# Drawing Change Notice

CHANGE DOCUMENT NO.  
24590-LAW-M5N-V17T-00019

JOB NO. 24590	TITLE FOR CHANGE NOTICE Add HEPA Filters Before the Inlets to LVP Fans in LVP-SKID-00003	
DESIGN DOCUMENT NUMBER 24590-LAW-M5-V17T-00011	REV NO 5	TITLE OF DESIGN DOCUMENT Process Flow Diagram LAW Vit Secondary Offgas Treatment (System LVP)
PART OF DESIGN CHANGE PACKAGE (DCP)? <input checked="" type="checkbox"/> No <input type="checkbox"/> Yes		DCP No.: _____ Rev: _____
JUSTIFICATION FOR CHANGE HEPA filters will be added before the fans in LVP-SKID-00003 to align with the current design.		TREND CODE-NUMBER N/A
Supersedes Change Document <input checked="" type="checkbox"/> No <input type="checkbox"/> Yes

LVP-FAN-00001/2

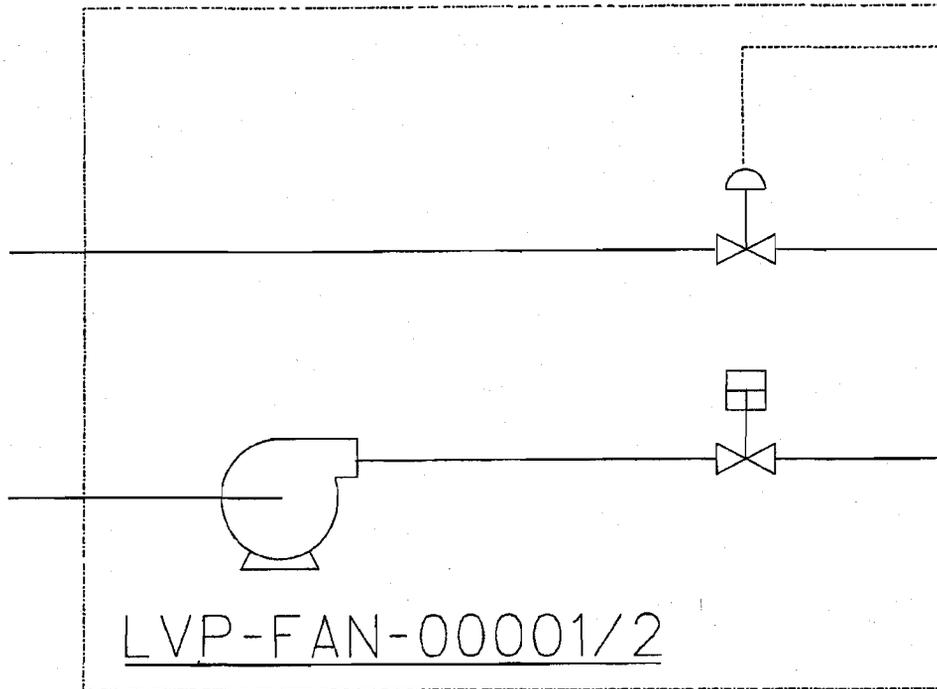
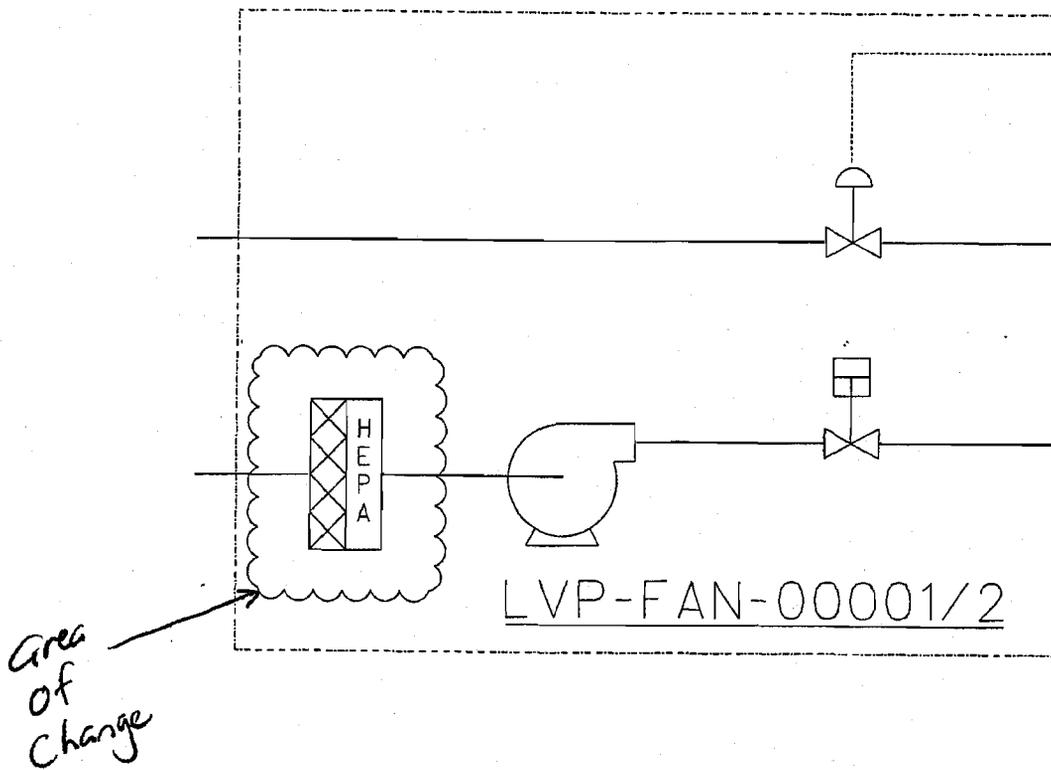
In Sector 6-A, add HEPA filters before the LVP-FAN-00001/2 inlets.
